TECHNICAL ALERT

No: TA501-001

Second Row Seat Release Strap Anchor Failure

Land Rover LR3 (LA)

Figure 1

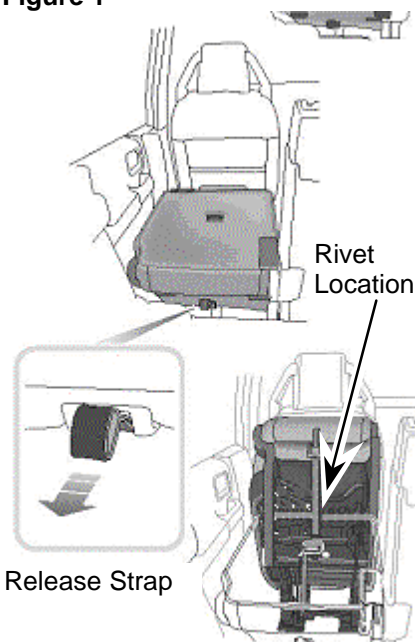
Field reports indicate that in use the second row seat bottom release strap (intended for third row passenger use to exit the vehicle and flip the seat bottom to the forward access position) can become disengaged from its retaining location. The retaining plastic rivet may have come loose. When this occurs the release latch will not disengage and the strap handle will pull out without resistance.

1. Release seat using side lever and flip to the forward position.
2. If present, remove Fir tree plastic rivet from the end of the strap and check that no part of the rivet is still lodged in the seat bottom.
3. Route the strap correctly to activate the latch. Use an undamaged seat for reference.
4. Align hole in strap with attachment hole in the bottom of the seat platform frame.
5. Insert specified rivet through the hole in the strap webbing
6. Install the rivet using the swivel head tool. (Figure 3 and Figure 4)
7. Test latch release function.
8. Place seat in the unfolded and latch position and test to ensure that the latch works properly.
